County of Los Alamos

Staff Report for Case No. SIT-2019-0034 Site Plan for a Drive Through Fast Food Restaurant.

Public Hearing Date: May 22, 2019
Subject: Case No. SIT-2019-0034
Property Owner: Shannon Corp, LLC / JEA Restaurant Group
Applicant: Agent Craig Calvert; Modulus Architects, Inc
Case Manager: Anita C Barela, Associate Planner

A2.2

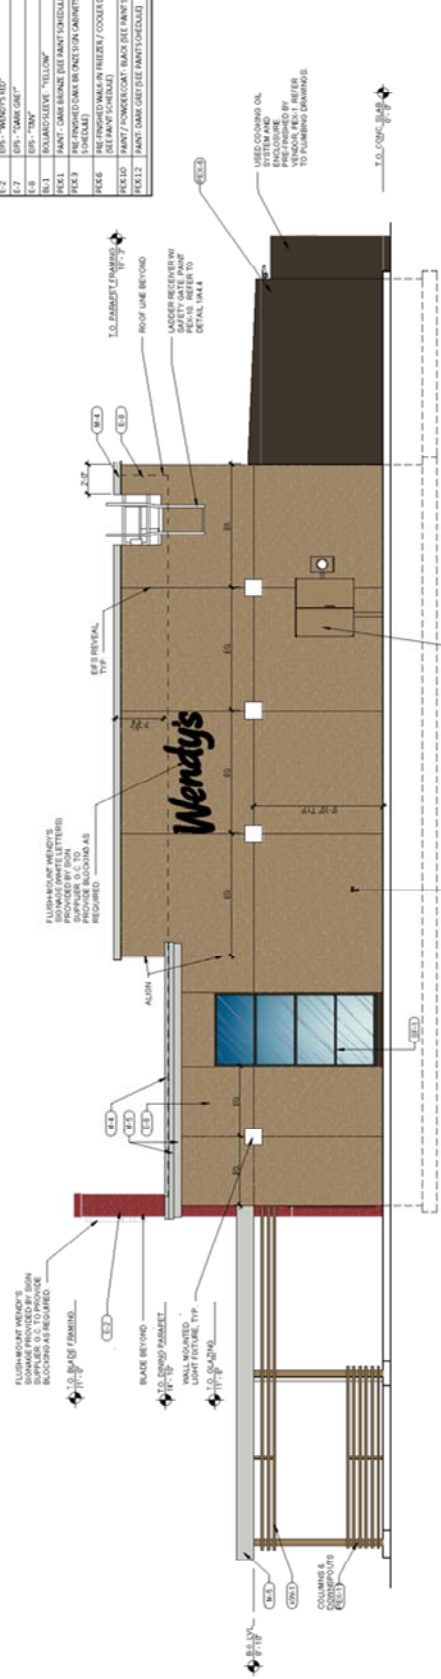
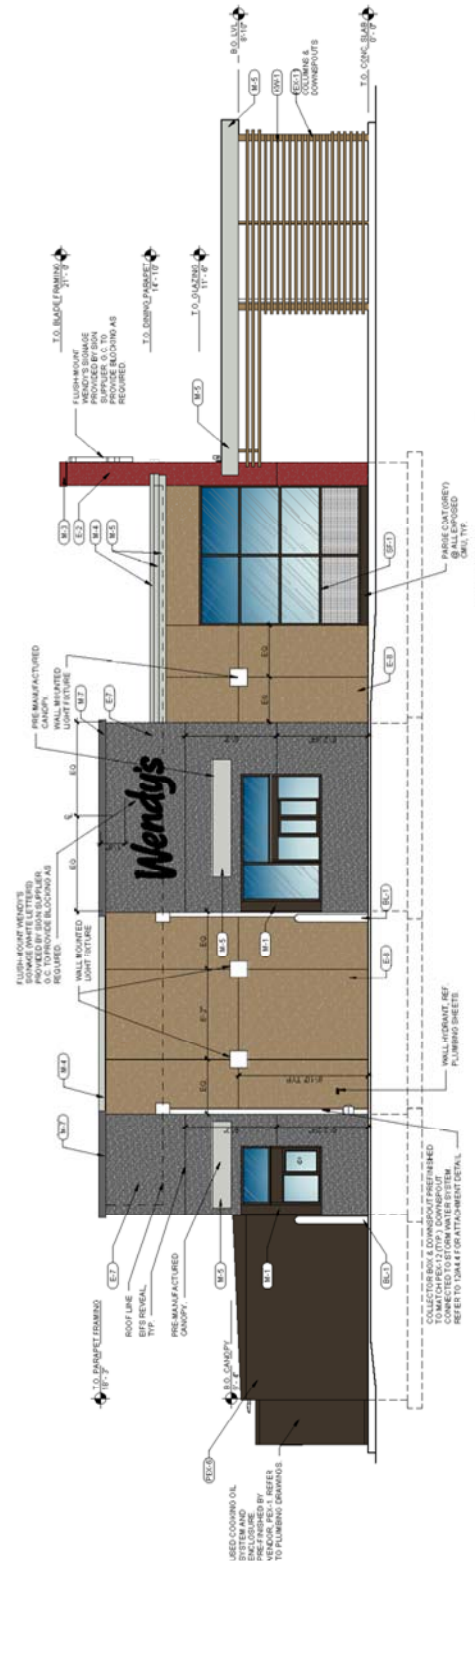
Elevations Submitted: To comply with these standards, the proposed construction materials include Exterior Insulation and Finish System (EIFS) in red, grey, and tan, accented by various metals (used for the banding feature), and natural colors, including “dark bronze” as a main color, and powder coat paint in black and dark grey ; Anodized metal accents will also provide architectural relief to the proposed structure. The total window surface area does not exceed 40% of the total exterior wall surfaces.

To meet Architectural Massing requirements, the proposed structure features a variety of roof parapet styles and heights, an irregular footprint accented with a well-balanced series of rectangular architectural features that avoids long stretches of flat walls, and the use of multiple types of building materials and colors.

LS1.1

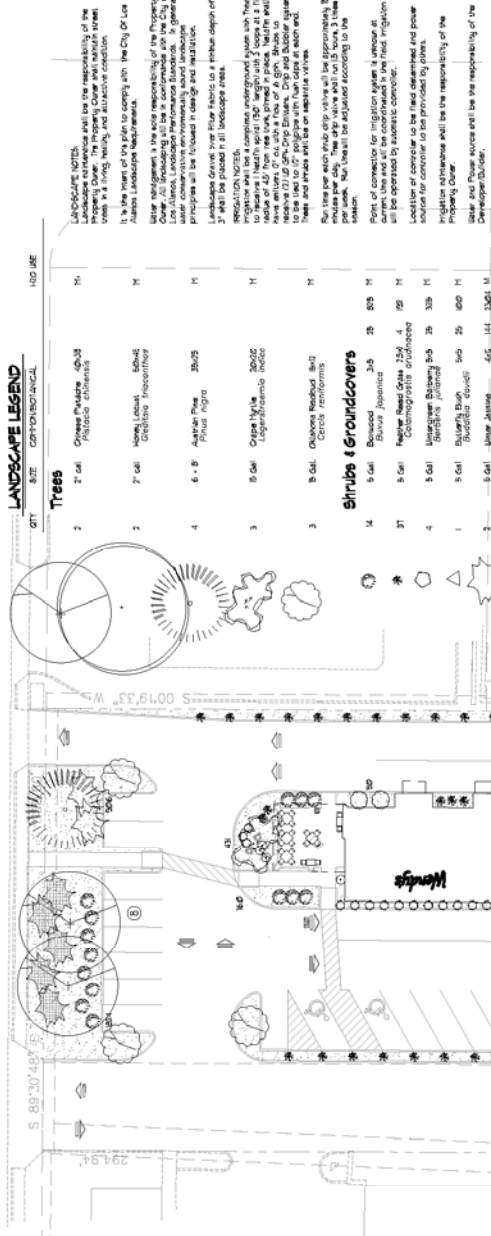
Staff Comment: The Landscape Plan submitted in support of the revised Site Plan exceeds the minimum five percent requirement for landscaping material, as required by Section 16-574 and Section 16-575 of the Los Alamos County Development Code. It is strongly recommended that all existing trees be protected during construction. A detail note shall be placed on the revised landscape and construction plans. [Planning]
